Odisha Gramya Bank

RFP No. : OGB/ITD/ATM/CD/2016/001

Corrigendum No: 3

Design Diagram of the Interior of the ATM room

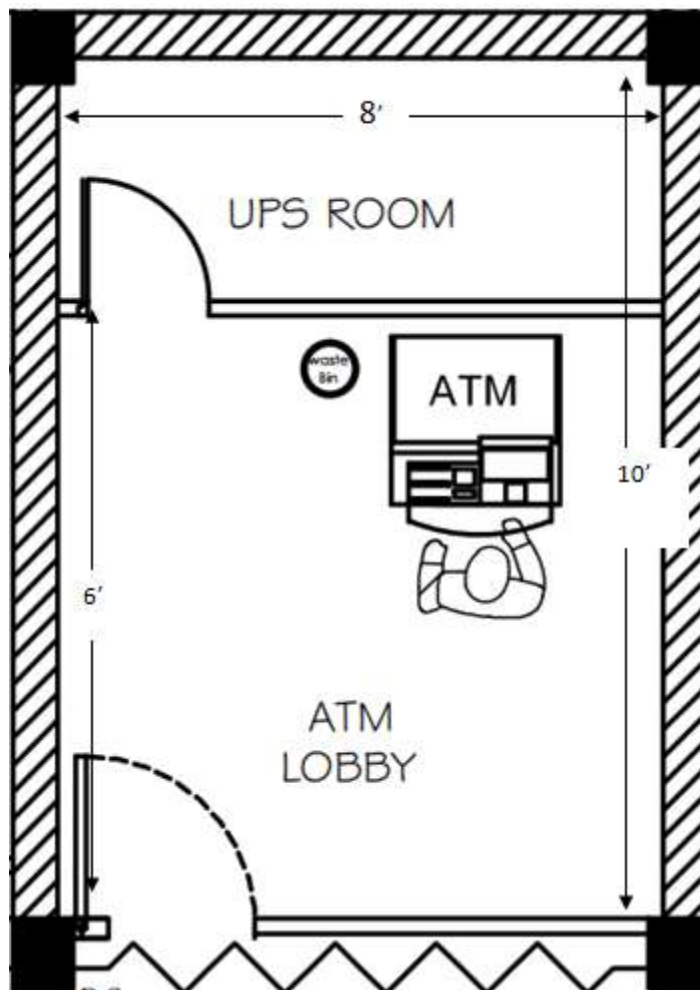
The design provided is of size 10' (length) x 8' (breadth). The design of the ATM room subject to actual size of available carpet area of the ATM room in different locations. Bidder need to setup interior design of the ATM room as per the design provided by the bank, using the available carpet area subject to prior approval of the bank. The cost or billing should be as per the actual usage or actual construction.
